traffic impact assessment;

St Ives Indoor Sports Complex

For Ku-Ring-Gai Council

1. 1175 St Ives Indoor Sports Complex – Response to Submissions

Attachment 1 Signage Plan

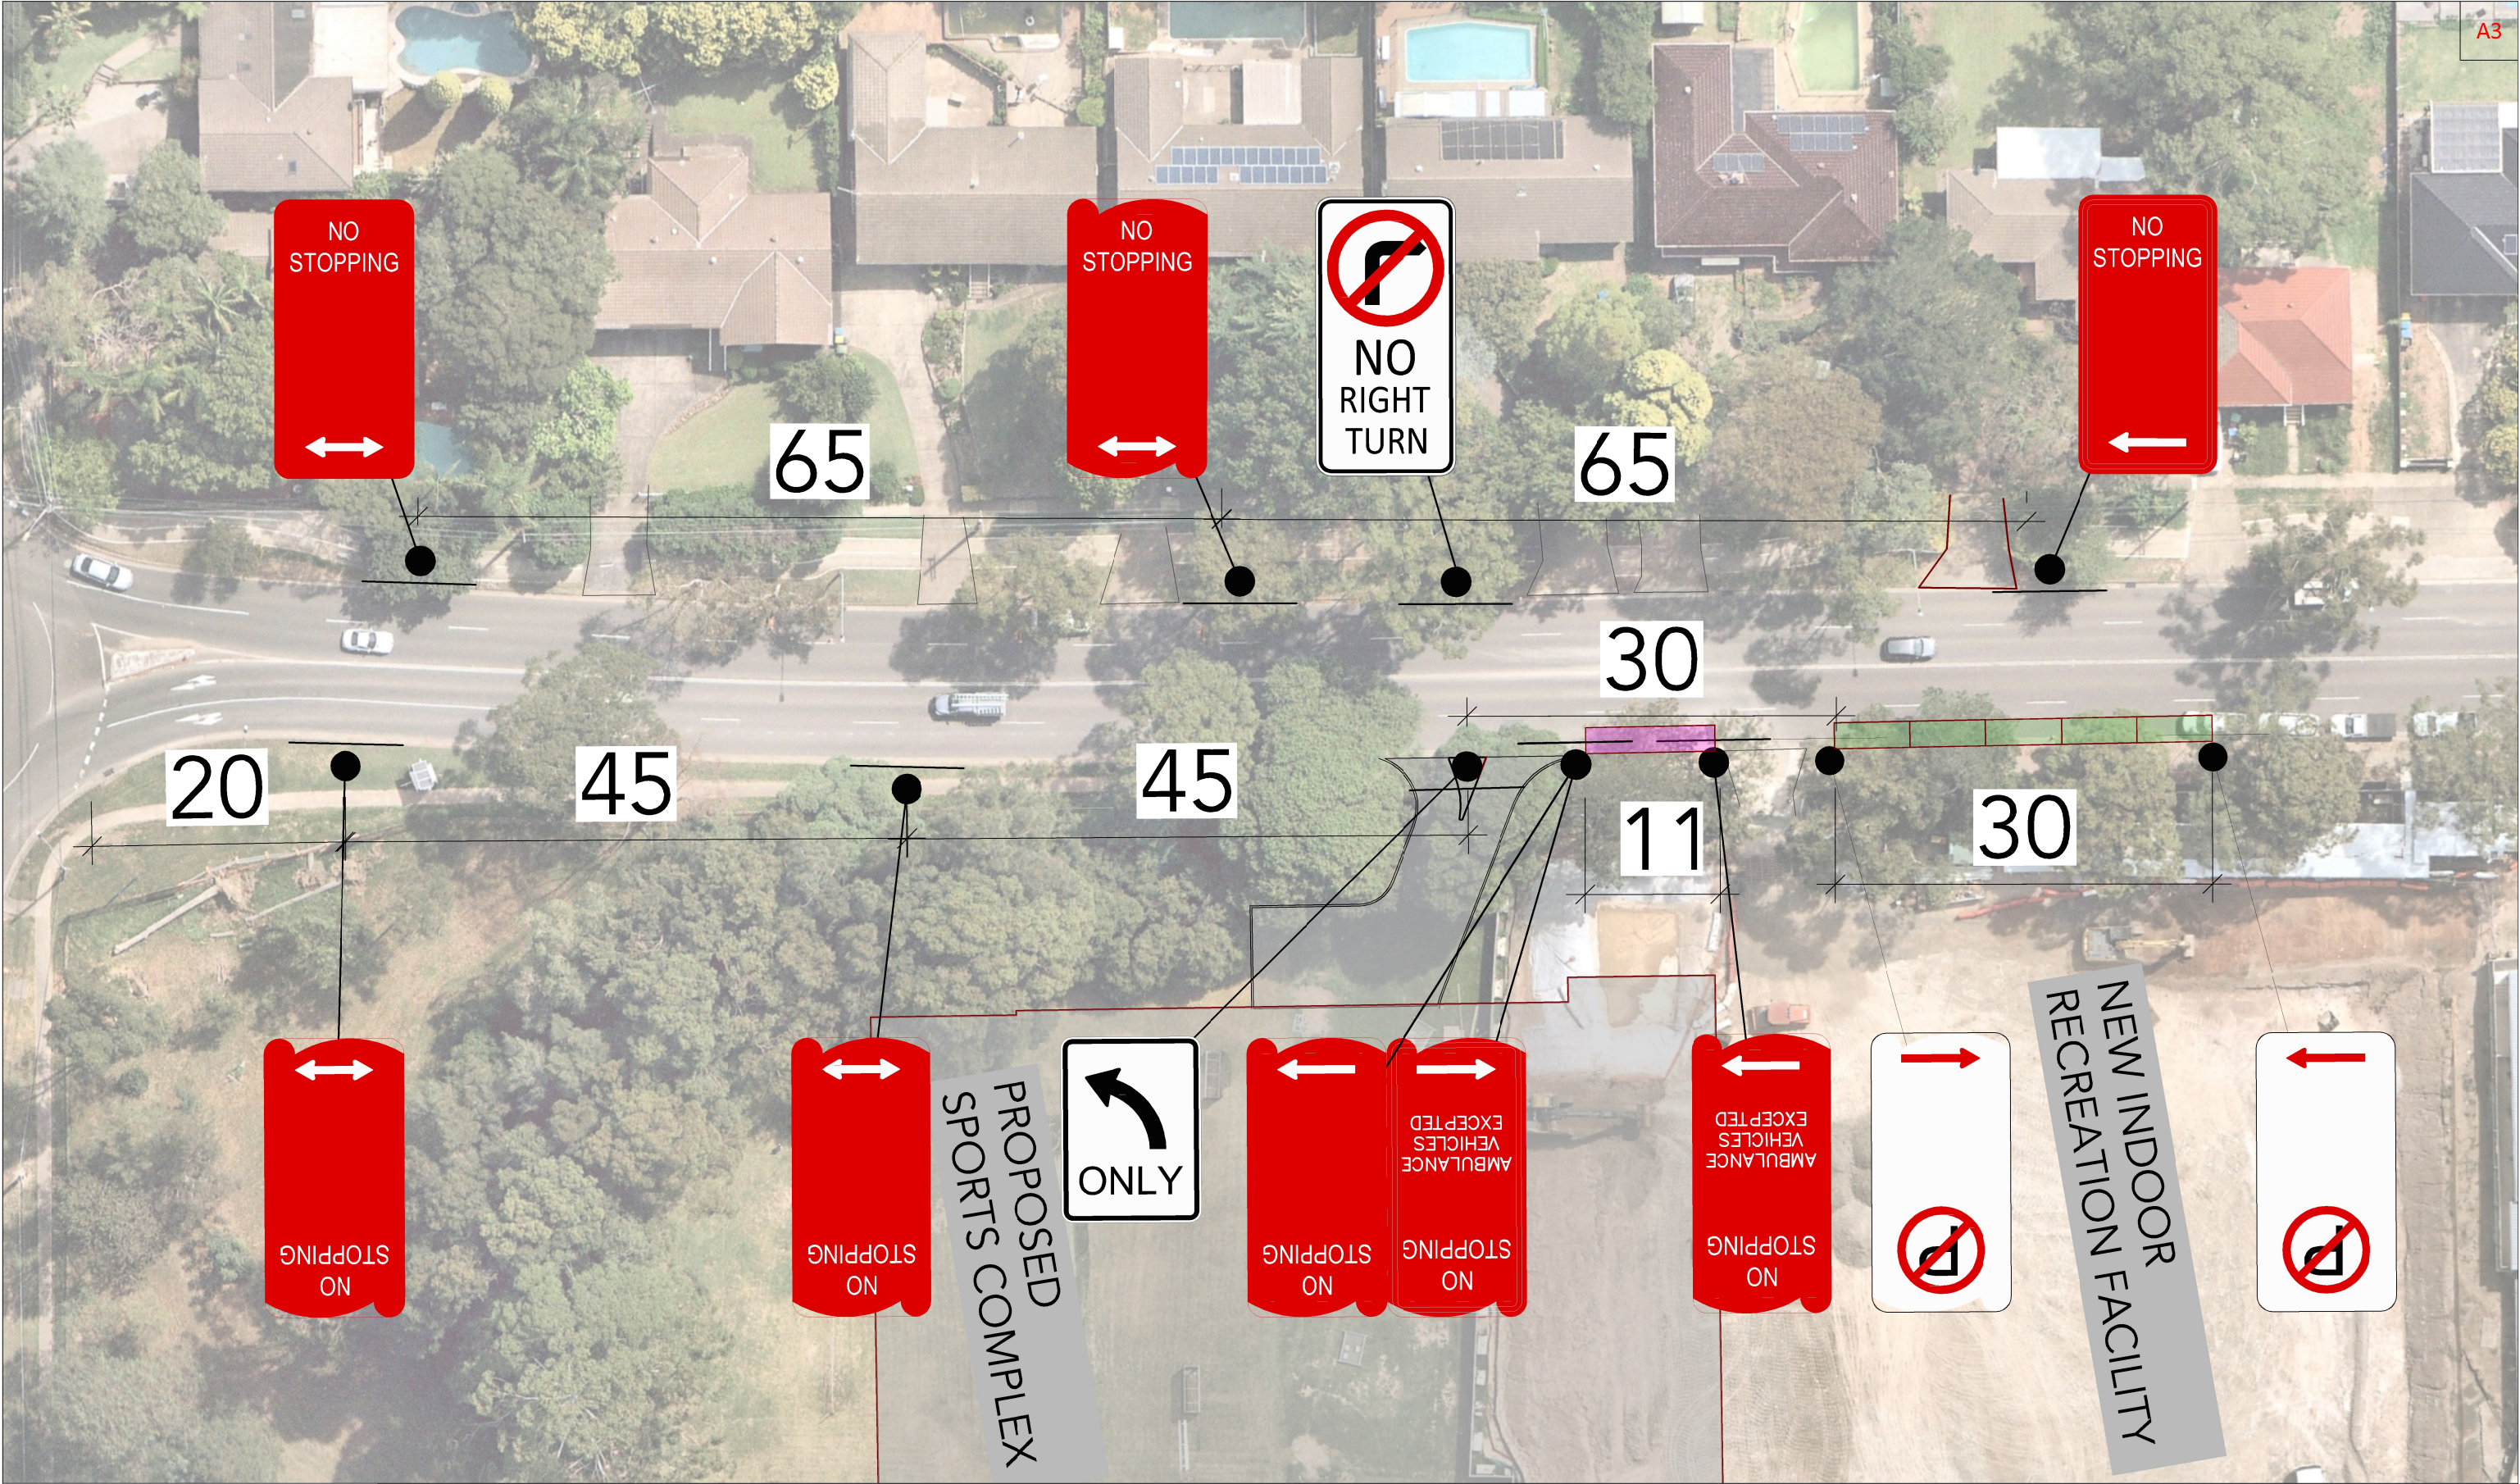
There are a number of incorrect signs shown on the signage and linemarking plan in Attachment 3 of the TIA.

The signage and linemarking plan should be updated to meet TfNSW requirements and be in accordance with AUSTROADs and other Australian Codes of Practice.

The signage plan has been amended (see Attachment 1) as per the phone consultation undertaken with TfNSW on 1st November 2021. The amendments include the following:
